From: Chanel Gibson <chanel5@ozemail.com.au>
Sent: Sunday, 9 September 2018 10:04 PM
To: Joel Herbert
Cc: Michelle Niles
Subject: FURTHER OBJECTION TO DEVELOPMENT PROPOSALS MP_07 0166 MOD 8

MP07_0166 Mod 8 is an application seeking to modify the Wahroonga Estate Concept Plan by providing detailed amended residential building envelopes and amended residential car parking rates for Precinct B: Central Church Precinct. The modification does not seek to alter the total maximum dwellings approved under the existing Concept Plan.

Indicative solar access diagram

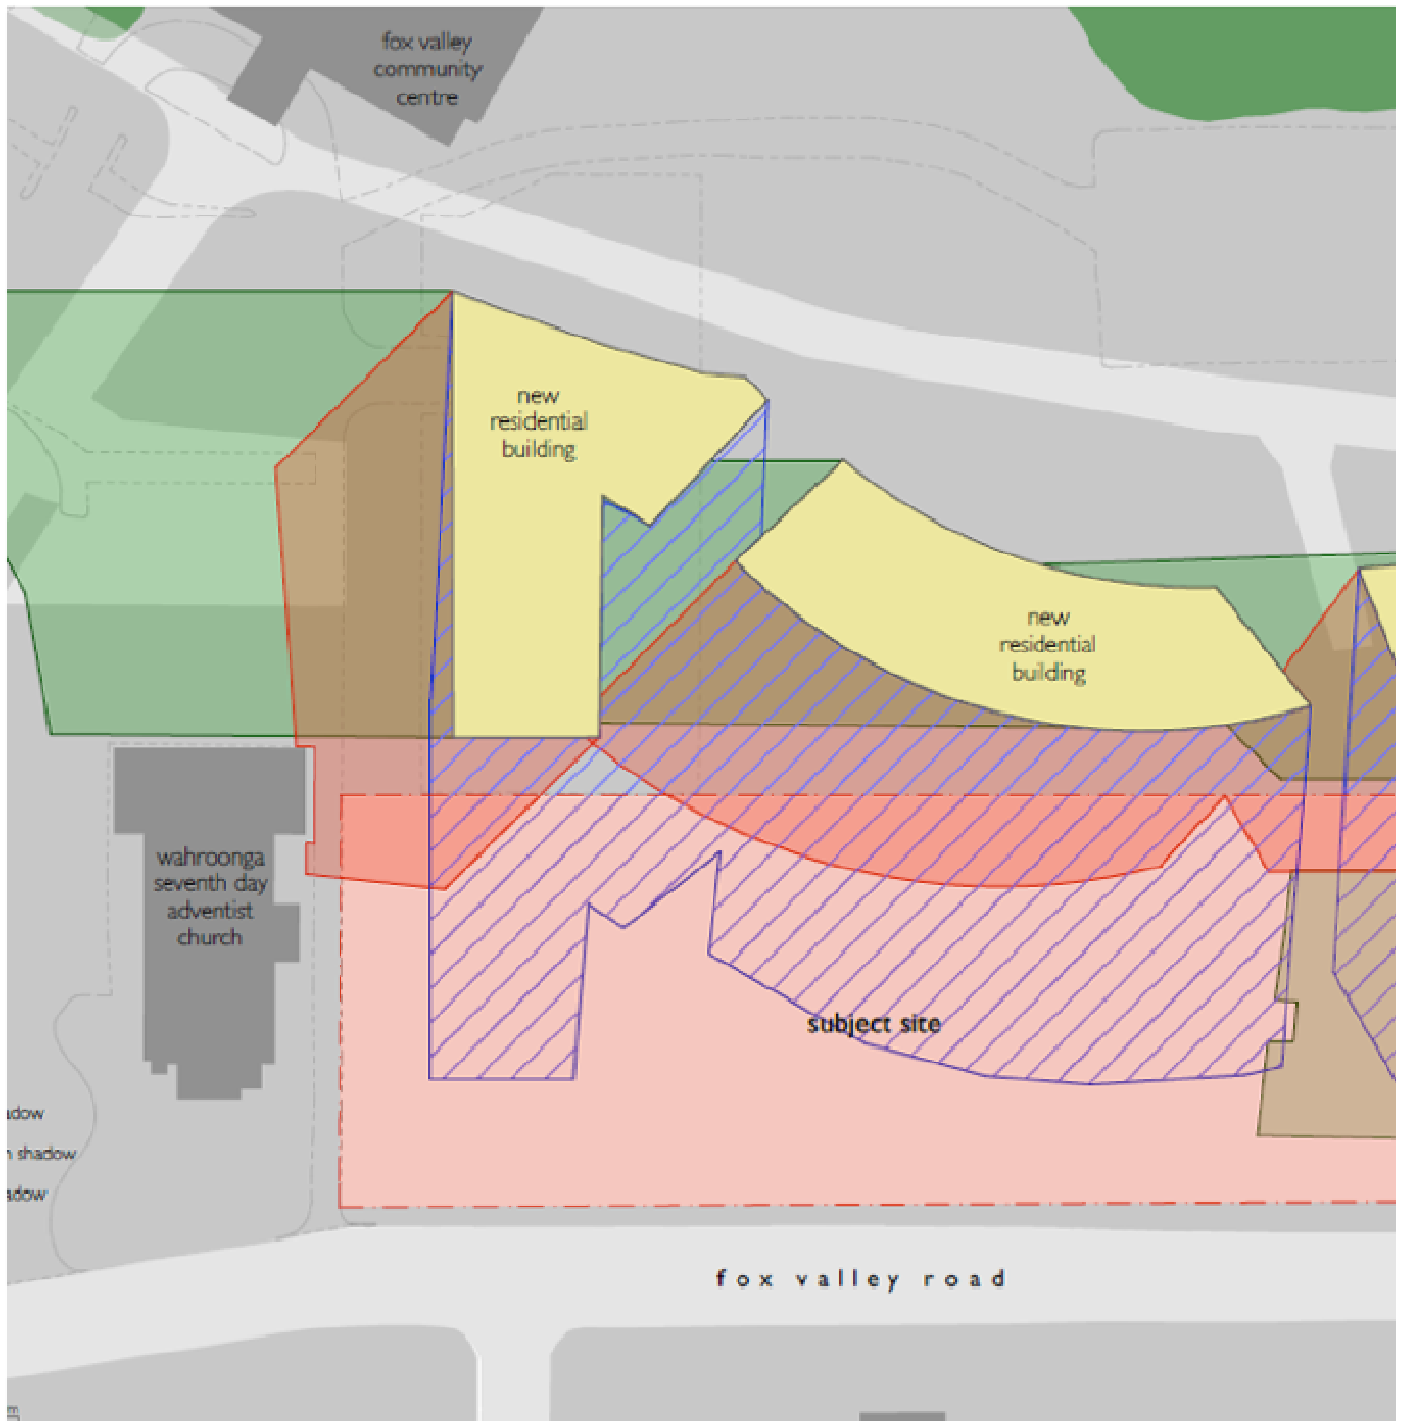
Whilst the amended plans, have amended the location of the building envelopes slightly, it can be seen from the above diagram that a large proportion of the school site will remain in shadow. Accordingly, it is considered that the concerns remain valid and the proposal will result in negative adverse impacts on the adjacent school site. The proposed Mod 8 application to increase the height planes and height limits of the buildings should not be approved and the detailed floor plans should also not be approved for the above reasons.
